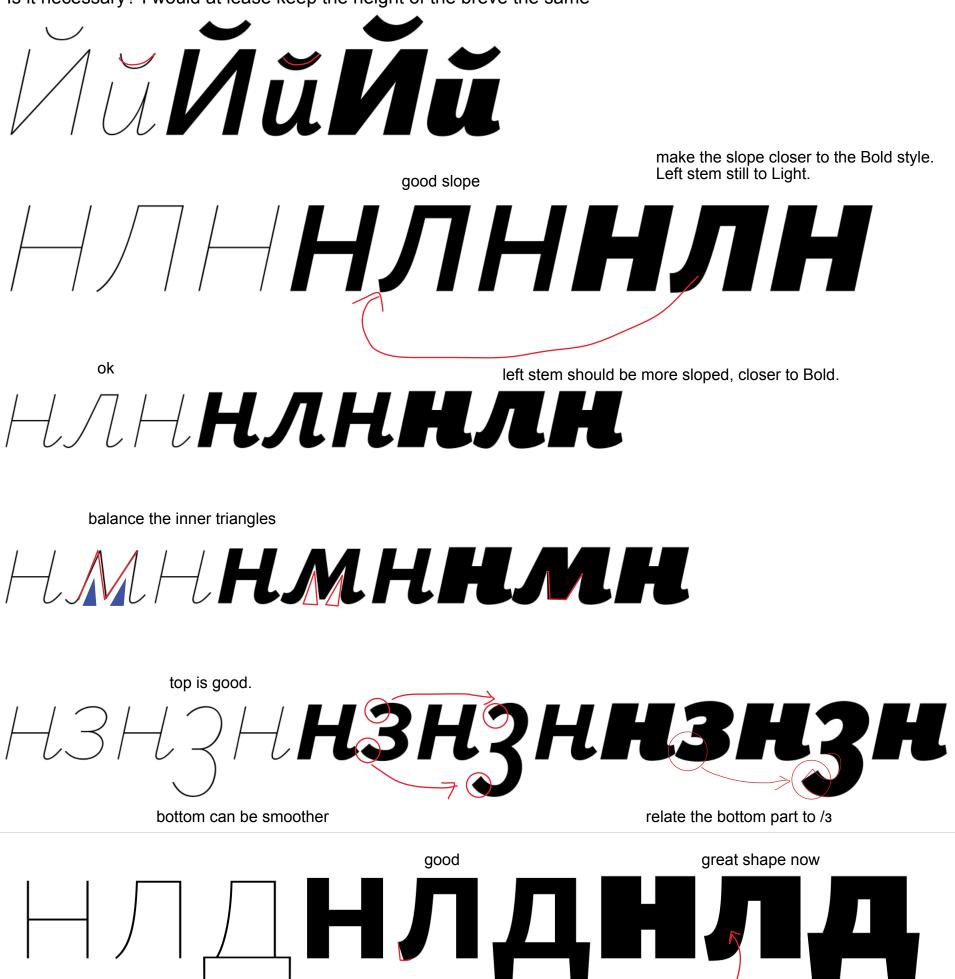
There is a serious design language (modulation) change in Thin style. Is it necessary? I would at lease keep the height of the breve the same

left stem a bit too thin
